From: LAUDERMILK II, HOWARD <HL1596@att.com>
Sent: Tuesday, September 12, 2023 12:30 PM
To: Holloway, Andrew; ECKLEY, SCOTT D; Boring, Tammy; Brown, Lawrence; Bryant, Troy
Cc: Opsitnik, Andrew; Amnah, Zachary; STANFIELD, SHAYNE W
Subject: RE: ODOT SR-435 Telecom Conflict

From: Andrew.Holloway@dot.ohio.gov <Andrew.Holloway@dot.ohio.gov>
Sent: Tuesday, September 12, 2023 8:37 AM
To: LAUDERMILK II, HOWARD <HL1596@att.com>; ECKLEY, SCOTT D <SE1236@att.com>; Tammy.Boring@dot.ohio.gov; Lawrence.Brown@dot.ohio.gov; Troy.Bryant@dot.ohio.gov
Cc: Andrew.Opsitnik@dot.ohio.gov; Zachary.Amnah@dot.ohio.gov
Subject: RE: ODOT SR-435 Telecom Conflict
Importance: High

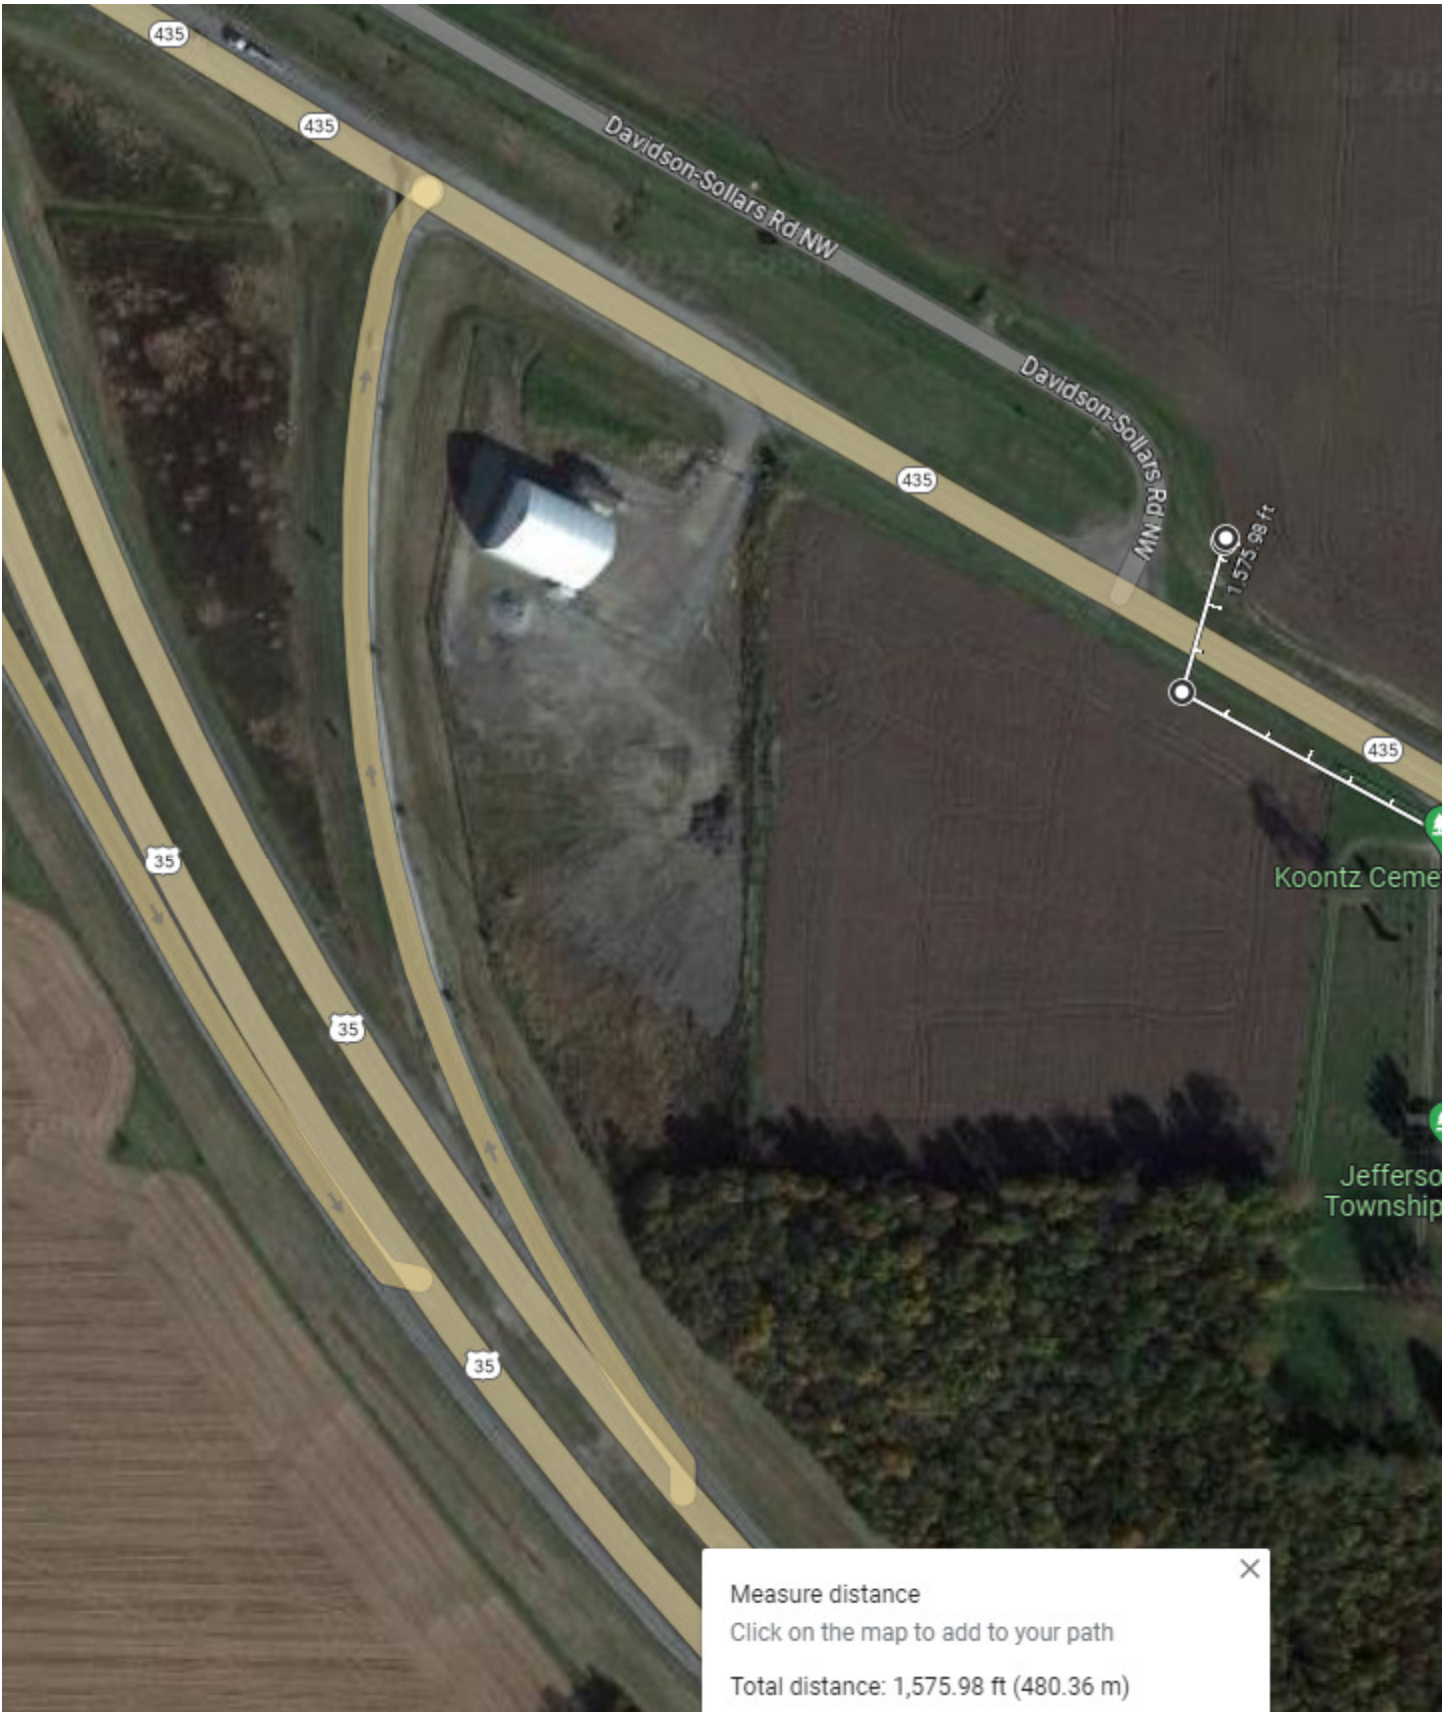
Please see the request below. Additionally, could you provide information on AT&T facilities east of the SR-435/Bluegrass/SR-729 intersection from the intersection to the bridge over "Missouri Ditch". The plan Scott sent shows the duct bank ending at this intersection, but our survey picked up a pedestal/box east of the intersection (see attached image).

Thank you for the information Howard; I think we can avoid/minimize relocation of the duct bank along SR-435. But, the box east of Bluegrass will need to be relocated outside of the construction limits along with a segment of the fibers running north & east; see attached plan sheet. The fiber running east will need to be relocated from the box at roughly 111+25 to 114+50 as the foreslope & ditch will be lowered and the line will be uncovered assuming it is a standard 4' depth. The fiber running north will need to be relocated from existing to proposed box.

It appears that the main duct structure turns down OH-729 and doesn't continue east on old 35. I believe the box you see east of blue grass feeds north and east direct buried. I think Scott may have some as build information on the new fiber placed east of that box if needed.
